RE: Addendum No. 2 – Waller County Bid 25-002 – Construction of Justice Center Vehicle Maintenance Garage

ADDENDUM #2 July 25, 2025

**Waller County - Vehicle Maintenance Garage 200 Sheriff R Glenn Smith Dr.
Hempstead, TX 77445**

FOUNDATION NOTES:
1. TOP OF CONCRETE ELEVATION = SEE PLAN
2. SLAB THICKNESS = SEE PLAN

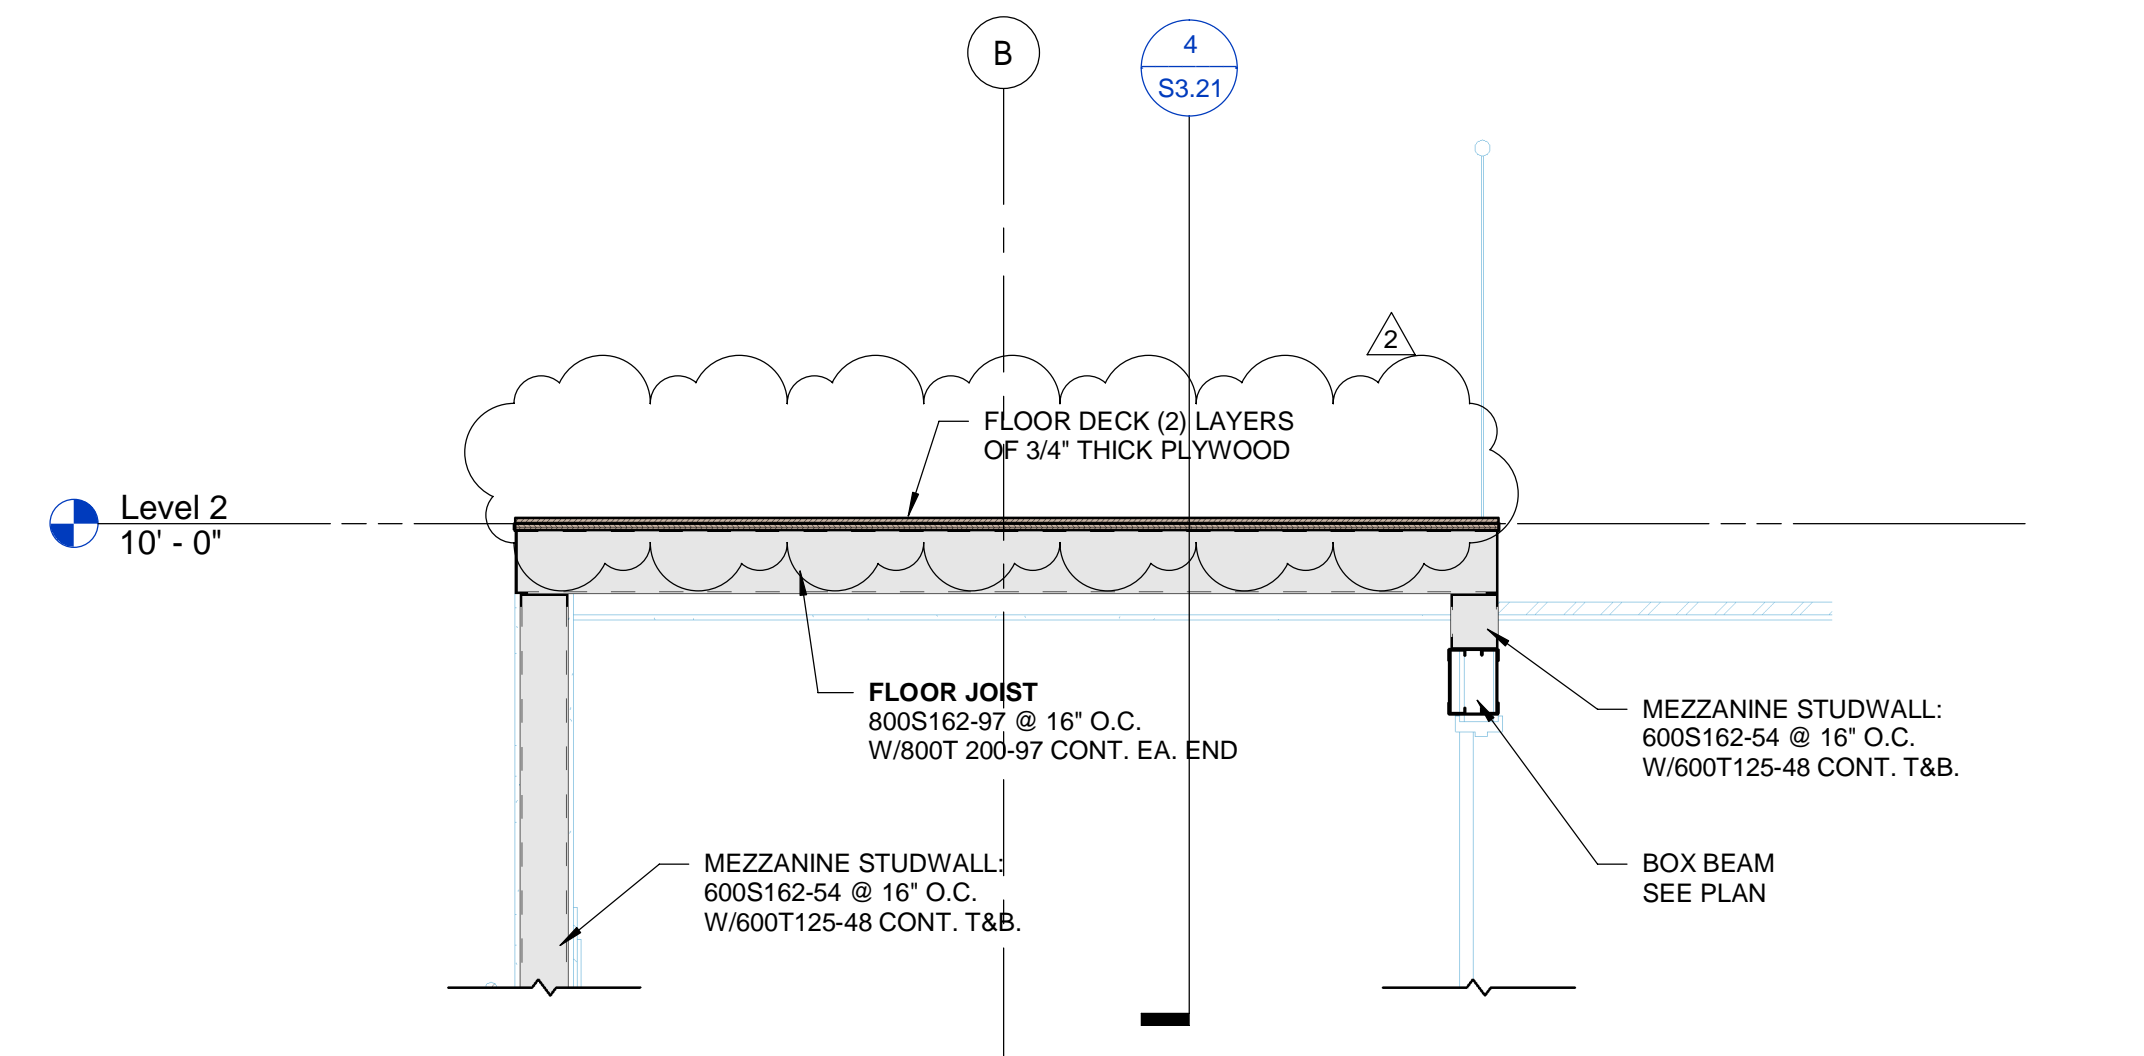
- 1. ... Mezzanine... thickness not shown- please clarify.**

1. Sheet S1-10 – Added slab notes. Added a 2nd layer of floor sheathing to the mezzanine level.
2. Sheet S3.21 - Added a 2nd layer of floor sheathing to the mezzanine level on details 1 -
